RESPONSE TO FURTHER INFORMATION PLANNING REPORT

DUNDRUM CENTRAL - PART 10

PROPOSED RESIDENTIAL DEVELOPMENT ON LANDS AT THE FORMER CENTRAL MENTAL HOSPITAL, DUNDRUM ROAD, DUNDRUM, DUBLIN 14

ABP Ref. ABP-320912-24

Figure 2.3.2: Extract from updated Barrett Mahony Consulting Engineers Drawing entitled Roads Finishes, Road Markings & Signage (Dwg. No. DCD-BMD-00-00-D-C-11001, Rev P5, enclosed with this response).

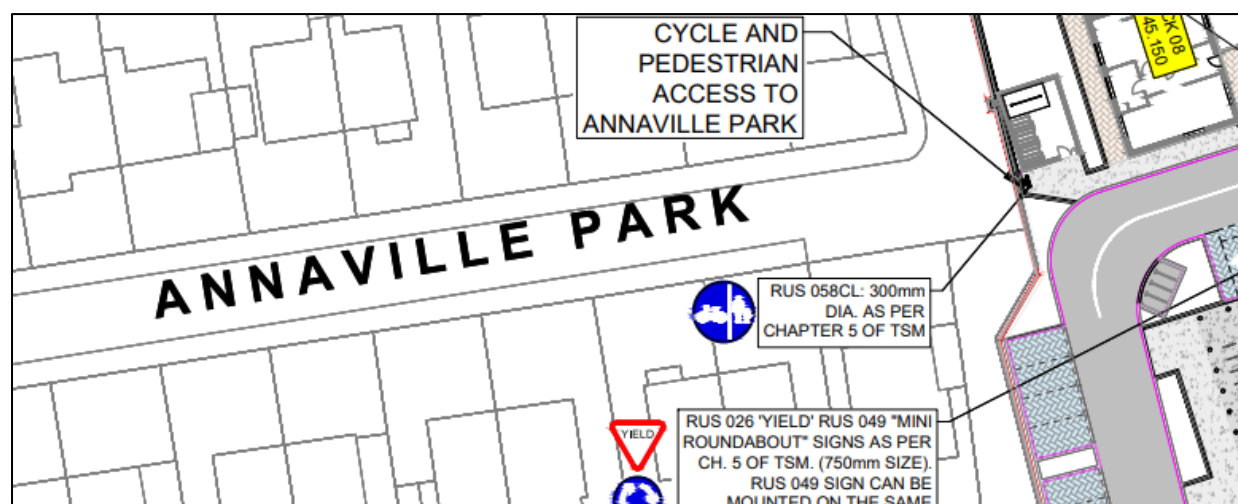
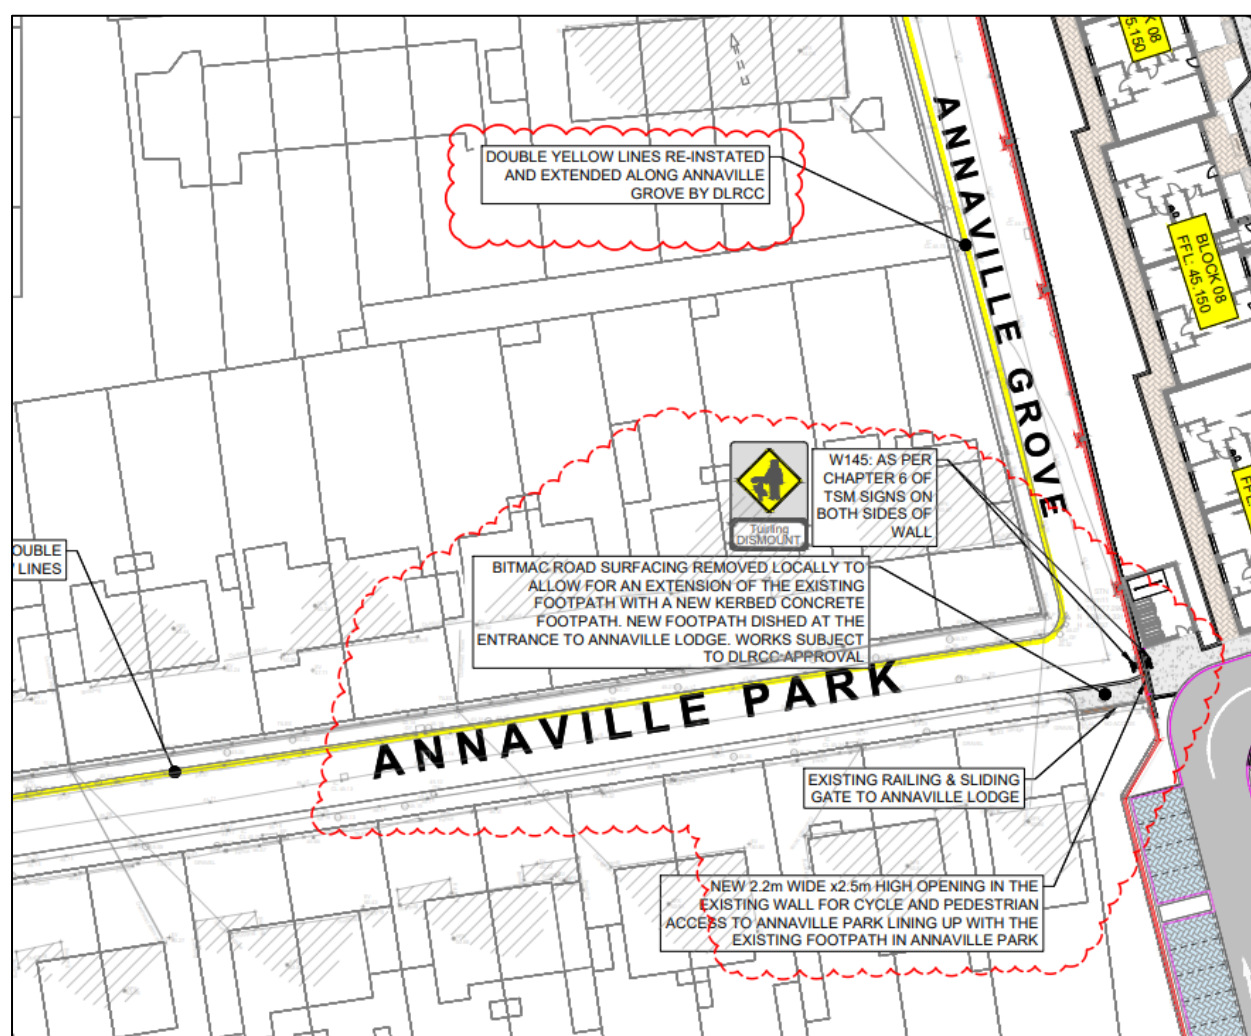
(a) Notwithstanding the submitted response to the National Transport Authority observation, the applicant is requested to clarify the design of the proposed cycle route and priority arrangements for cyclists/pedestrians in accordance with the Cycle Design Manual (National Transport Authority, 2023). In this regard, the applicant is requested to clarify the apparent differences in priority arrangements in the 'Landscape Layout Overall Plan' (Drawing No. DSRM-ACM-00-ST-DR-L-1000) and the 'Road finishes, road markings and signage' drawing (No. DCD-BMD-00-00-DR-C-11001).

(b) *Notwithstanding the submitted response to the third-party observations, the applicant is requested to clarify the design rationale for the proposed cycle/pedestrian link to Annville Park/Grove, including:*

The enclosed Barrett Mahony Consulting Engineers Drawing entitled *Roads Finishes, Road Markings & Signage*, Dwg. No. DCD-BMD-00-00-D-C-11001, Rev P5, has been revised to provide combined pedestrian and cyclist zebra crossing points in accordance with the NTA Cycle Manual as well as additional signage to clarify the priority arrangements for cyclists/pedestrians. The Barrett Mahony Consulting Engineer's drawing should be relied upon in respect of the design of the proposed priority arrangements for pedestrians and cyclists, including road markings and signage.

The enclosed Barrett Mahony Consulting Engineers Drawing *Roads Finishes, Road Markings & Signage*, Dwg. No. DCD-BMD-00-00-D-C-11001, Rev P5, is updated to provide additional information in respect of this connection.

The Applicant is willing to accept a Condition from the Board to construct this alternative version of the proposed connection to Annville as shown on the attached BMCE drawing.

Figure 2.4.2: Unit B07-00-05 indicating relocation of window. (Source: Enclosed HQA.)

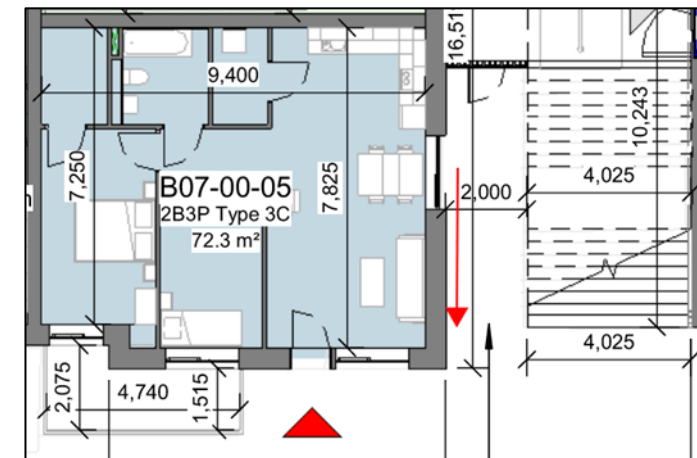
2.4.1.3 Item 4(c) – Block 7 Dual Aspect Design (Units B07-01-21, B07-02-21, B07-03-21, B07-04-21, B07-05-21, B07-06-12, B07-00-05, B07-00-03)

It is proposed to reposition the window on the east elevation further south, away from the podium edge, during the Detailed Design Stage to enhance access to both sunlight and daylight. The space in question is a living room that meets the minimum daylight/sunlight requirements. With the relocated window closer to the external edge this will be improved further.

Furthermore, oblique views to the southeast will be available from this window towards the open space located between Blocks 5 and 6. In relation to the above, the design team believes that this unit can be considered a dual aspect unit.

Figure 2.5.1: Drawing extract illustrating Privacy Hedge at Block 7. (Source: AECOM Drawing *Block 10 & 7 Planting Buffer Section* Dwg No. DCD-ACM-ZZ-00-DR-L-006003, 02.)

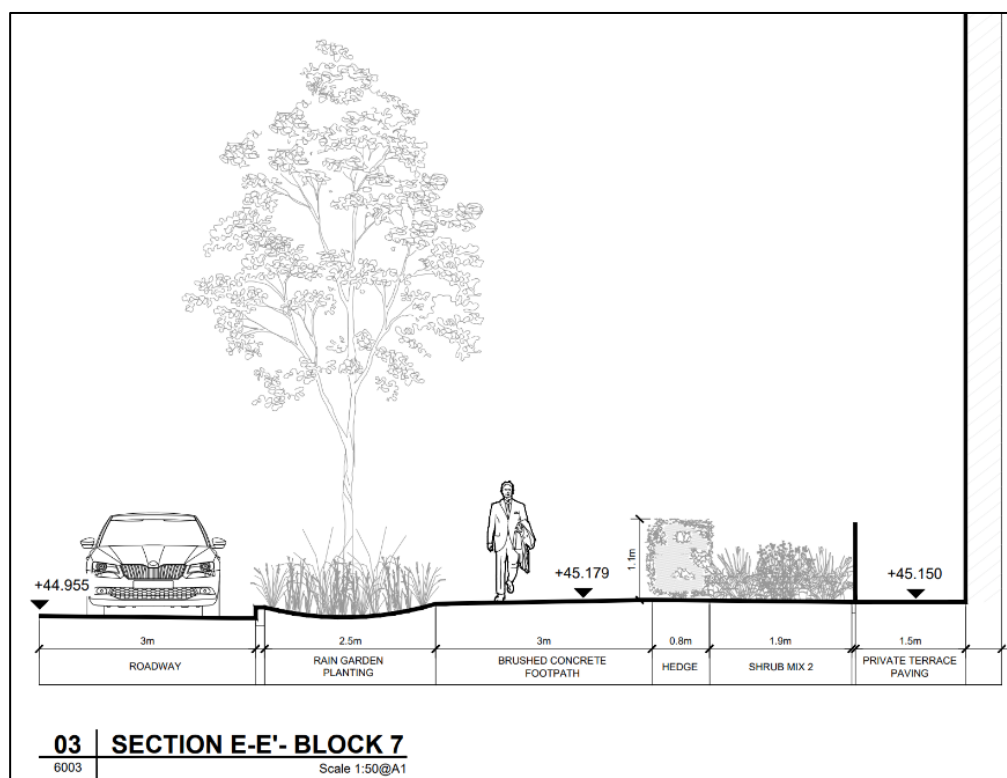
- Objective CMH5 of the Dundrum Local Area Plan 2023 is to 'Require the provision of privacy buffers for ground floor residential units'. The applicant is requested to demonstrate compliance with same, including the submission of drawings showing the interface with adjoining public/communal areas.
- The communal amenity space for Blocks 4&5, as stated in the Housing Quality Assessment Report, is less than that indicated on the 'Open Space Plan' (drawing no. DCD-02-SW-ZZZ-DR-RAU-AR-1004). The applicant is requested to clarify the correct figures.

The interface between Ground Floor Level units and adjoining public areas has been designed to provide privacy to those units. The landscaping drawings submitted with the Application include on the legend and the drawings 'Hedge Planting (privacy hedge planting to ground floor units)'.

The enclosed AECOM Drawing titled *Block 10 & 7 Planting Buffer Section* (Dwg No. DCD-ACM-ZZ-00-DR-L-006003, 02) provides supplementary Sections through the Ground Floor of Block 10 and Block 7. This illustrates the interface between the Ground Floor Level Private Terrace, Hedge Planting, and the adjoining Shared Surface/Footpath and Roadway. These Section Drawings show that the Hedge Planting will be c. 1.1m in height and 0.8m in depth (Block 10). In some cases (such as at Block 07) there will be additional separation provided by an area of Shrub Mix planting between the Private Terrace and the Hedge Planting, resulting in a separation distance of 2.7m between the Private Terrace and the outside face of the Hedge Planting.
